Product / Process Change Notification (PCN)

PCN #: PCN_WL-TIRW_20180928

Affected Series: WL-TIRW; 154005xxx

DESCRIPTION AND PURPOSE OF CHANGE:

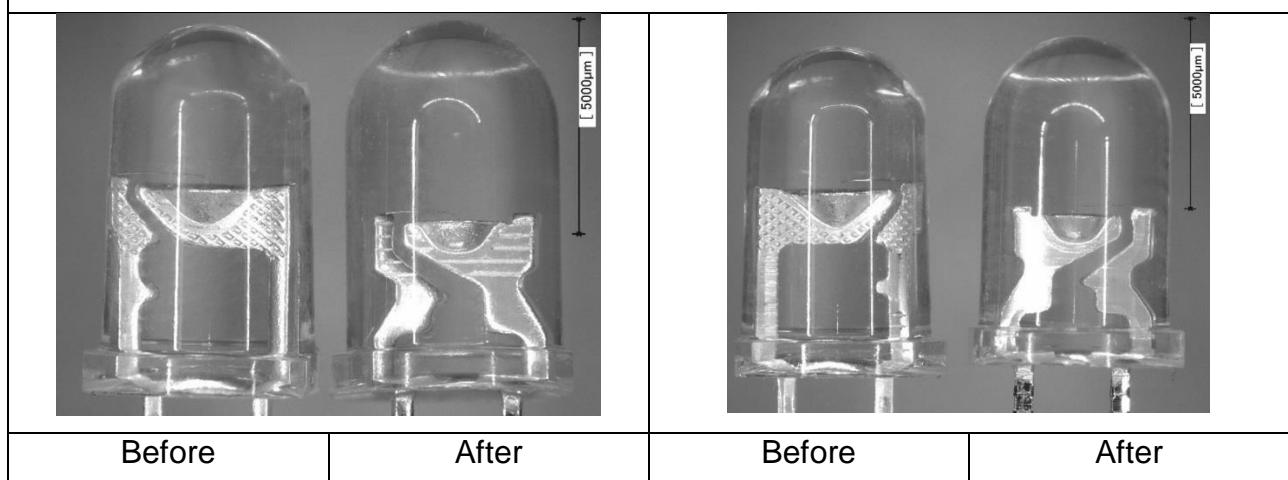
Due to external influences, Würth Elektronik change the lead frame of the products, without changing the characteristics of the product.

15400585xxx

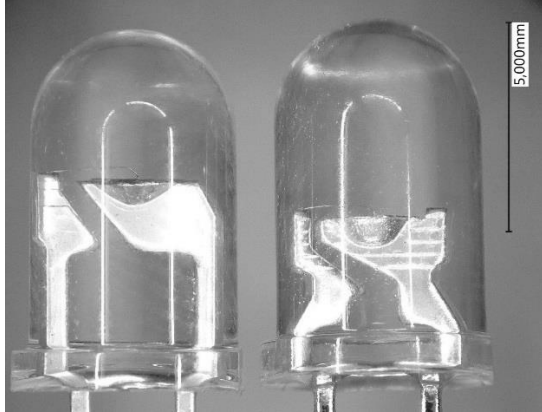
The Lead frame of the products changes, without change of the electro-optical parameters of the product.
